Screen Nova Scotia - Sound Stage Development Supplemental Information - Transportation and Stormwater Reponses to HRM and NSPW Comments

Project Number
23-085

Comments from: Nova Scotia Public Works

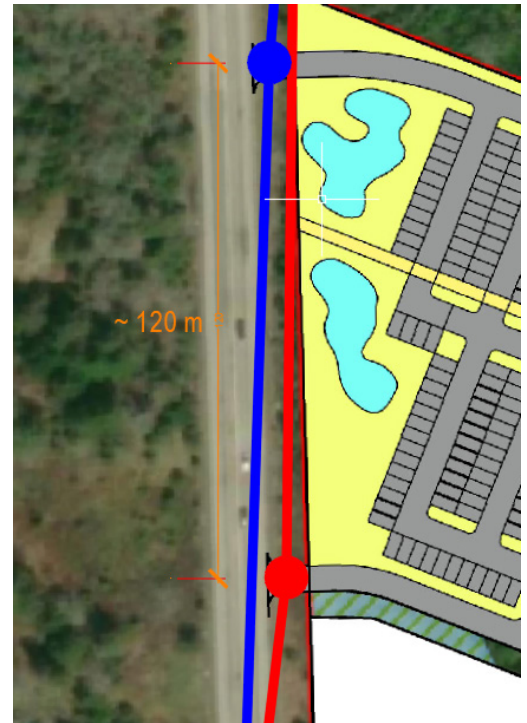
2. Label distance between accesses.

The distance between driveway centrelines is approximately 120 meters as shown in the figure to the right.

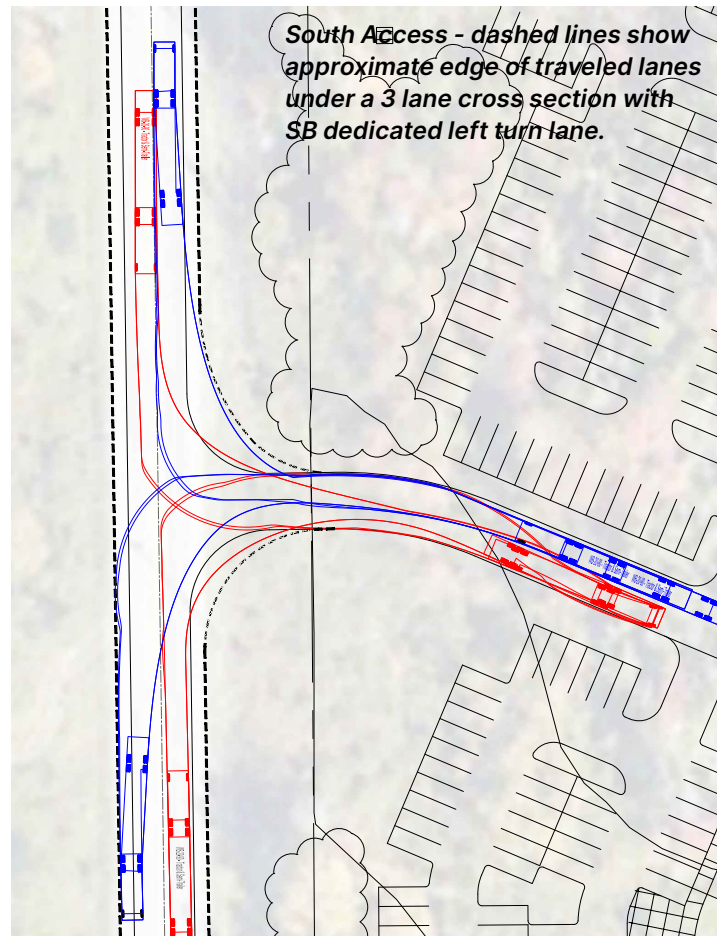
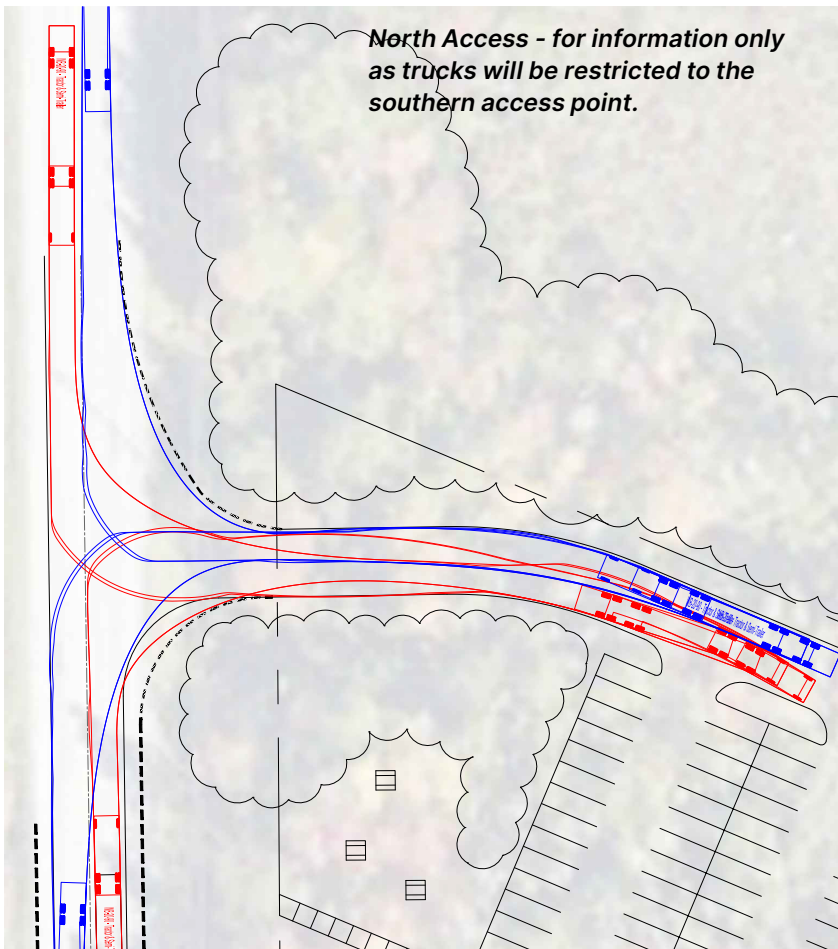
4. Please include truck turning templates for WB-21 (at both entrances).

The attached drawings show turning movements for both access points as requested using a standard Transportation Association of Canada WB-20 Design Vehicle. Two points are particularly relevant at this stage of the project:

- This project is still in the early approvals stages and detailed design work is not yet underway. Once the development is approved to proceed, additional details on truck turning and associated geometric requirements would be provided.
- The Transportation Impact Assessment indicated that the movement of large trucks to and from the site should be restricted to the central access point as there are sight distance restrictions at the north access for large trucks.

For informational purposes, the figures on the following page show that both intersections functionally operate in a very similar manner with the driveway corner radii being the critical geometric criteria that defines the ability of the truck to enter and exit Prospect Road without encroaching into adjacent lanes. It is anticipated that the central southern access will be constructed with two- or three-point compound curves on each radius to better accommodate the swept path of larger trucks. The northern access is expected to have reduced turn radii as truck movements will be restricted at this access point.

In anticipation of Prospect Road being widened to accommodate a dedicated left turn lane into the development, the figure to the below right shows the approximate edge of existing lanes on Prospect Road (dashed lines), with an expanded cross section which adds 1.75 meters to the outside of each lane. It is likely that as detailed design proceeds, the southern access will include a three lane cross section

(2 exit lanes and 1 entry lane) to better accommodate truck movements. Based on this preliminary analysis, larger WB-20 vehicles can be accommodated on site, provided that appropriate geometric design features are addressed during the typical detailed design process.
